CERTIFICATE OF APPROPRIATENESS

Property: 1115 Arlington Street, Lot 1, Block 198, Houston Heights Subdivision. The property includes a historic 2,532 square foot (including an addition constructed in 2000) residence situated on a 6,600 square foot (50' x 132') interior lot.

Proposal: Alteration – Addition *Revision*

SITE/ROOF PLAN

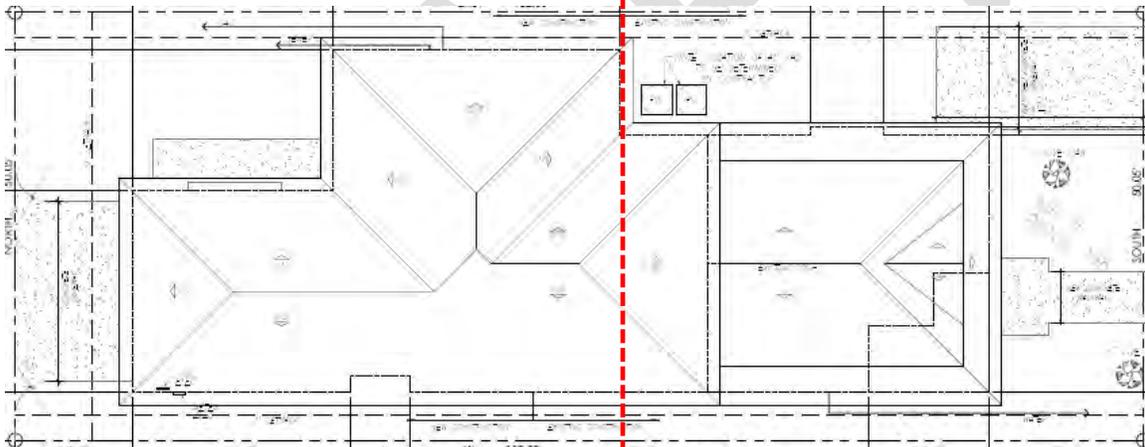
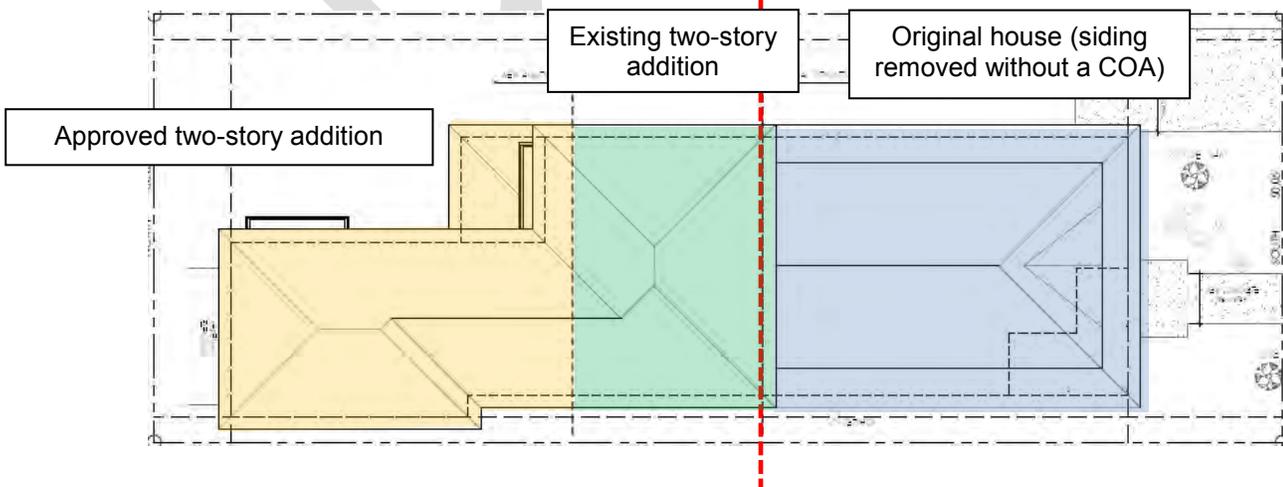
The applicant was denied a Certificate of Appropriateness for an addition on January 29, 2015 for failing to meet criteria for 1, 4, 8, and 9 for alterations to Contributing structures. Among the reasons why staff found the project to be inappropriate was the proposed removal of a large portion of exterior wall material and siding.

After staff consultation, the applicant revised their proposed addition to retain the existing siding and otherwise meet all 11 criteria for alterations. The applicant was granted a Certificate of Appropriateness for this addition on March 26, 2015. All of the existing wood 117 siding was stipulated to be retained.
